CALVERT CLIFFS NUCLEAR POWER PLANT, UNIT NO. 1

AMENDMENT TO FACILITY OPERATING LICENSE

Amendment No. 43  
License No. DPR-53

ATTACHMENT TO LICENSE AMENDMENT NO. 43

FIGURE 6.2 : Management Organization Chart - Calvert Cliffs Nuclear Power Plant  
Baltimore Gas & Electric Company

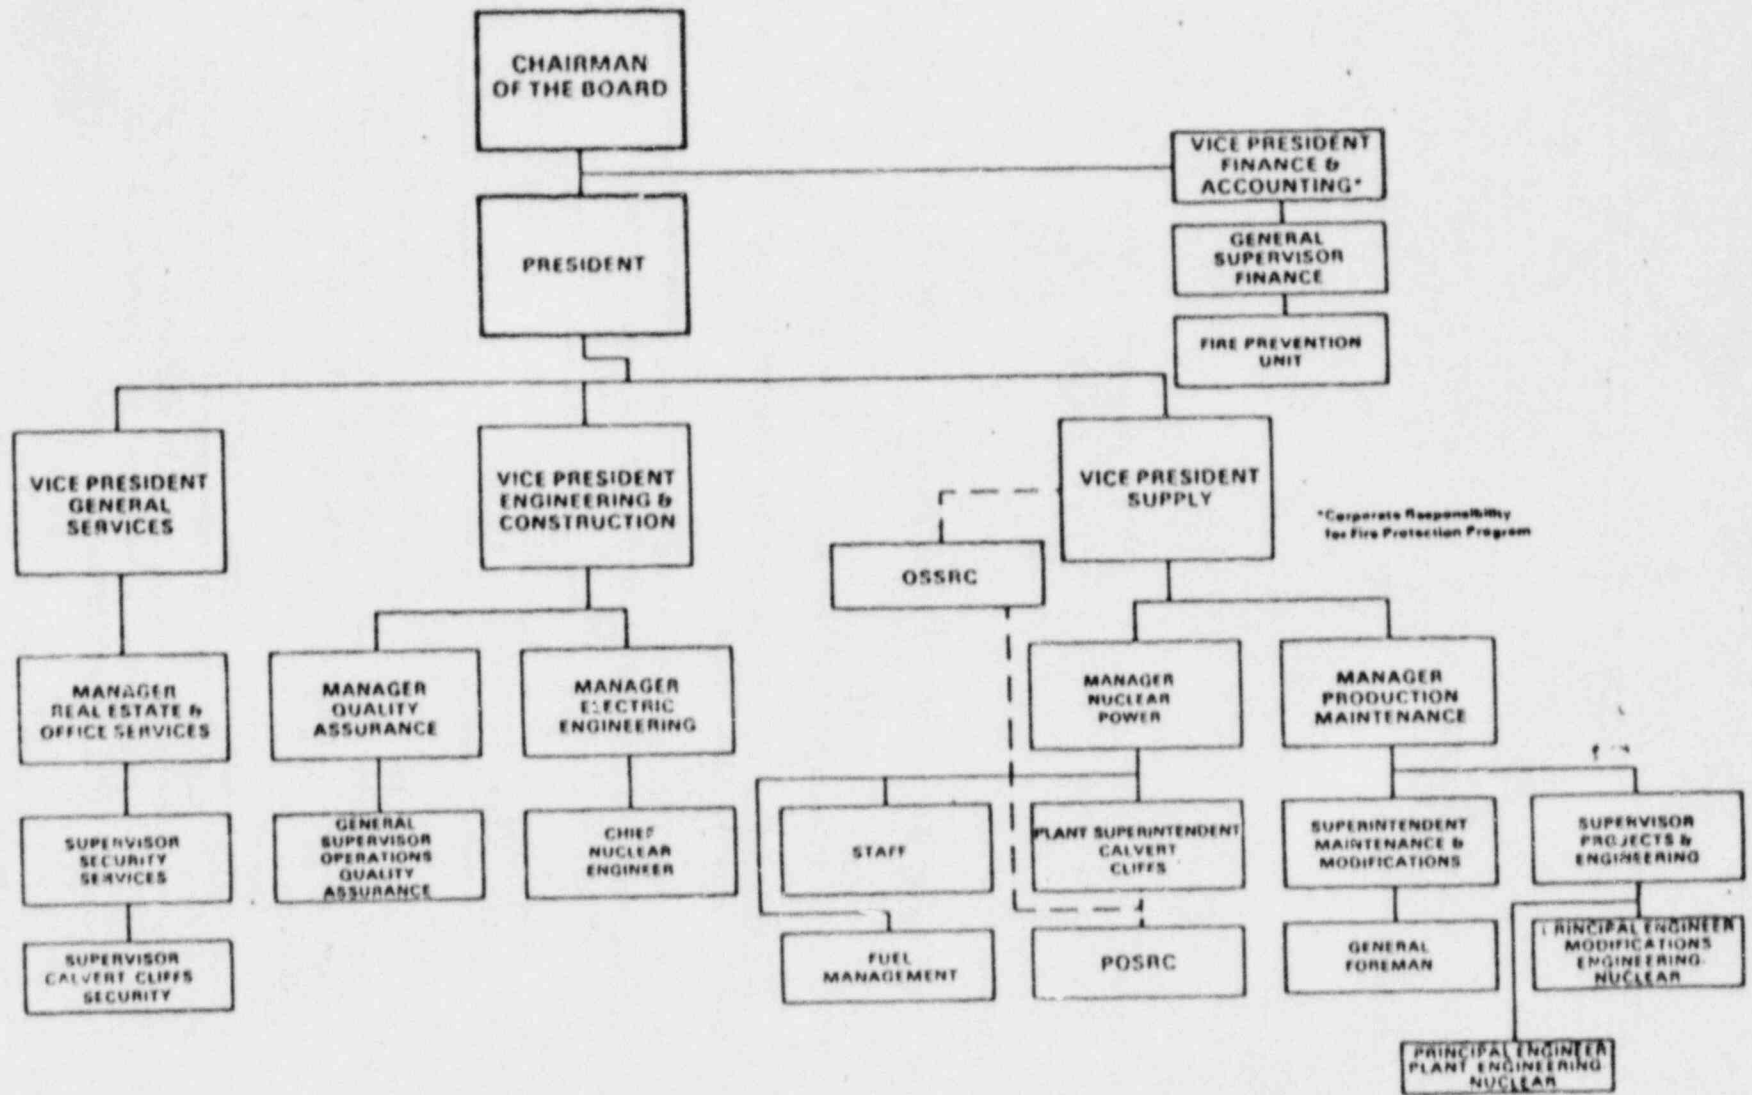
6.2.1 The offsite organization for facility management and technical support shall be as shown on Figure 6.2-1.

FIGURE 6.2.2 Organization Chart (Two Unit Operation) - Calvert Cliffs Nuclear Power Plant  
 Baltimore Gas and Electric Company

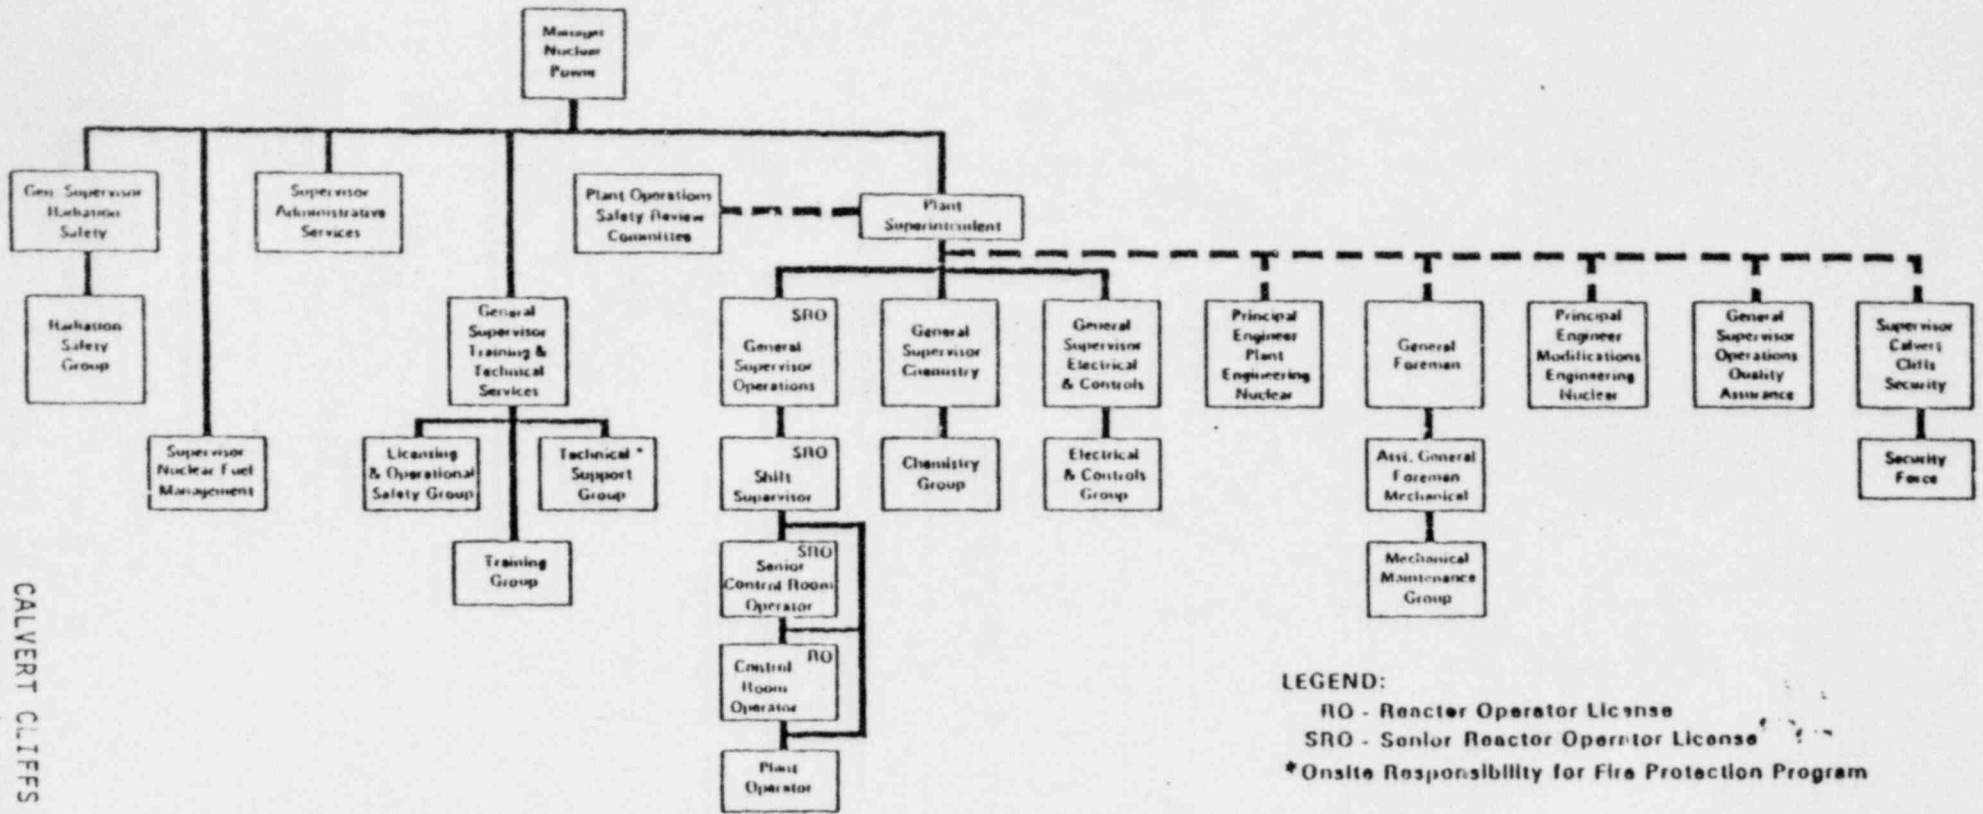
6.2.2 The Facility organization shall be as shown on Figure 6.2-2 and:

FIGURE 8.2-1 Management Organization Chart - Calvert Cliffs Nuclear Power Plant  
Baltimore Gas & Electric Company

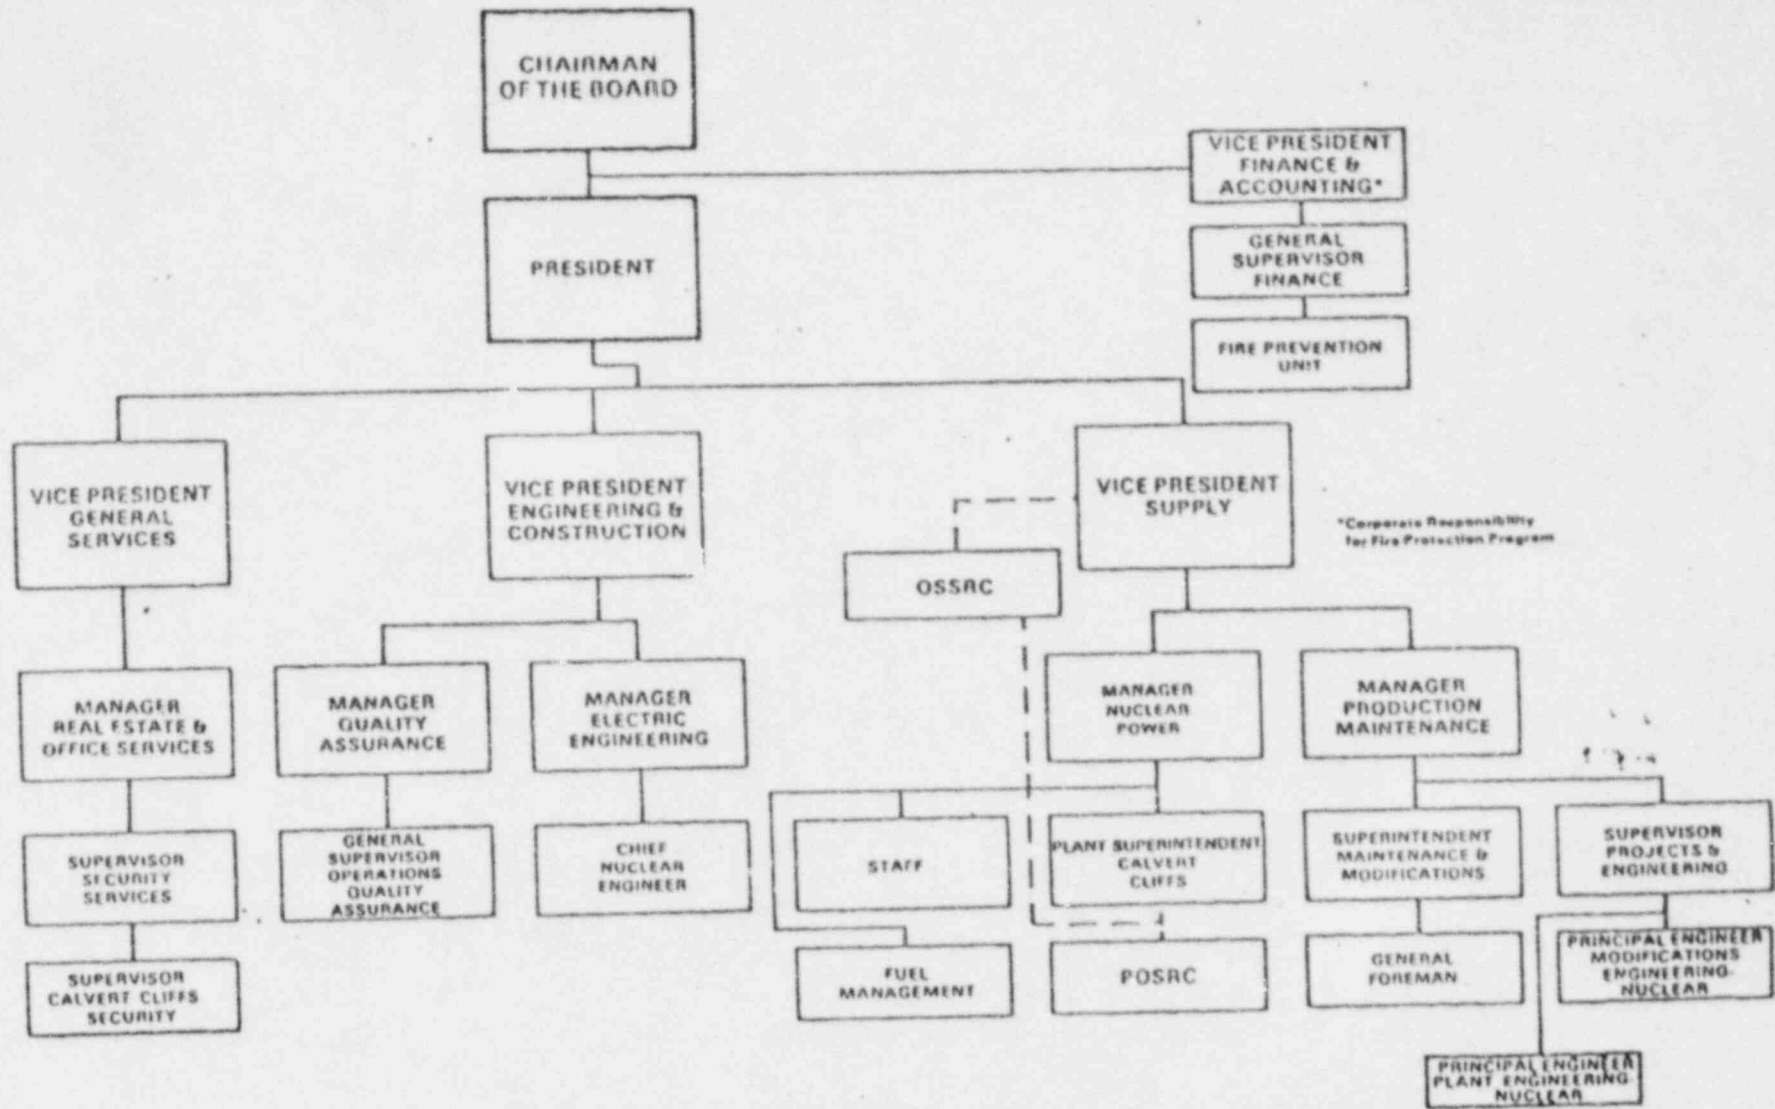
6.2.1 The offsite organization for facility management and technical support shall be as shown on Figure 6.2-1.

FIGURE 6.2.2 Organization Chart (Two Unit Operation) - Calvert Cliffs Nuclear Power Plant  
 Baltimore Gas and Electric Company

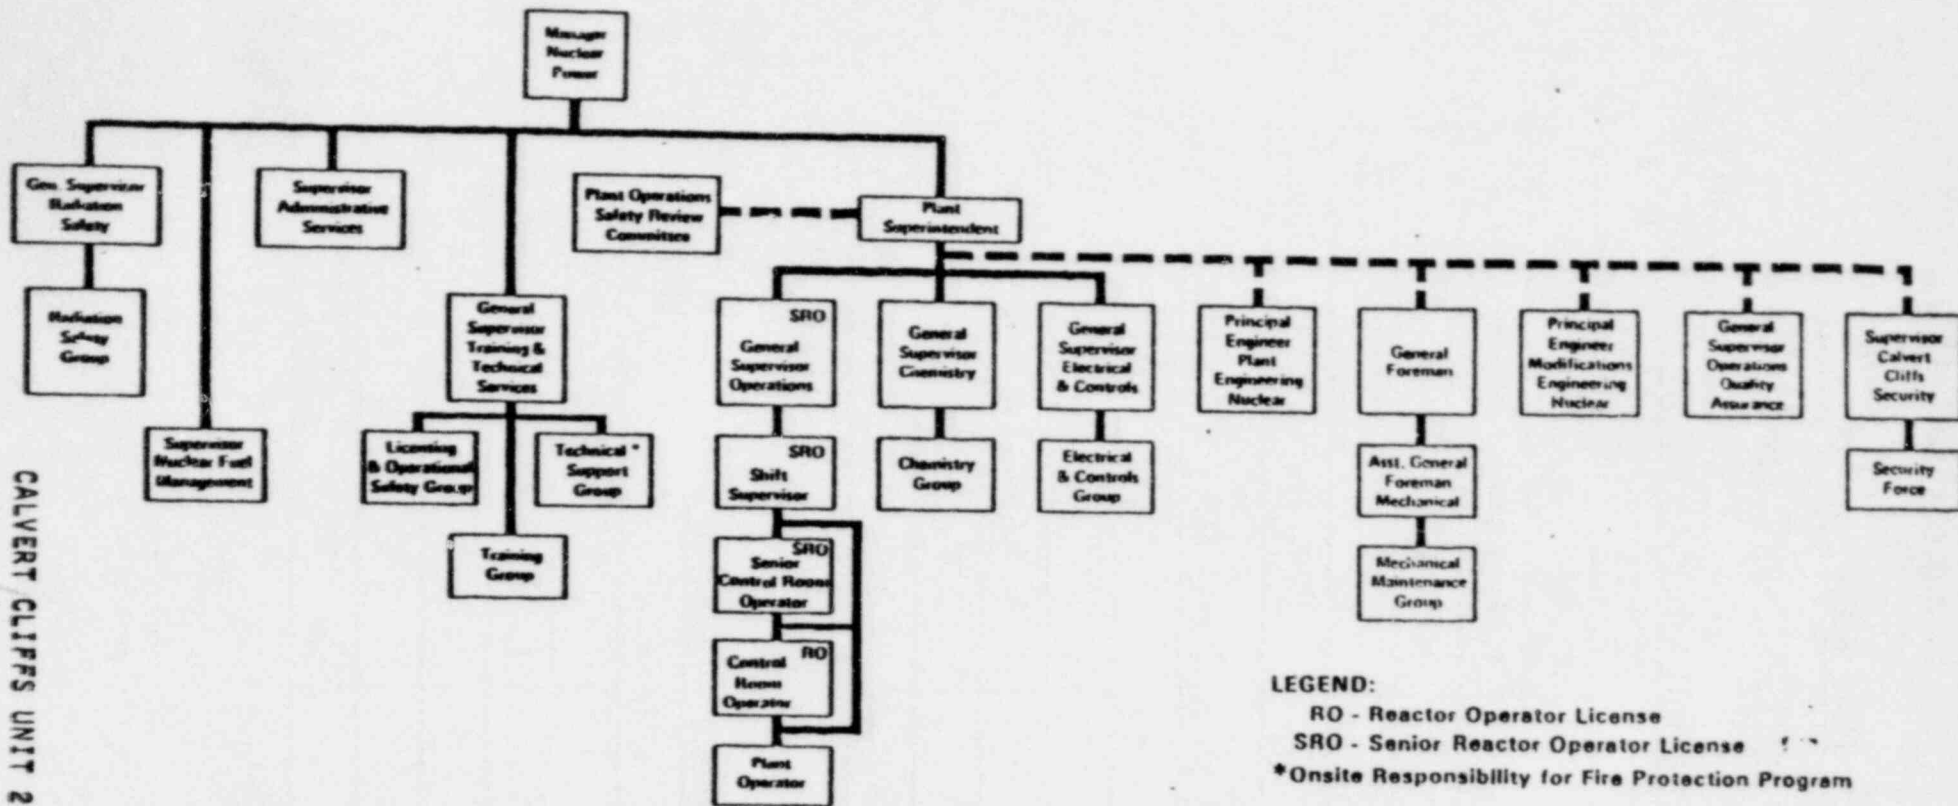
6.2.2 The Facility organization shall be as shown on Figure 6.2-2 and:
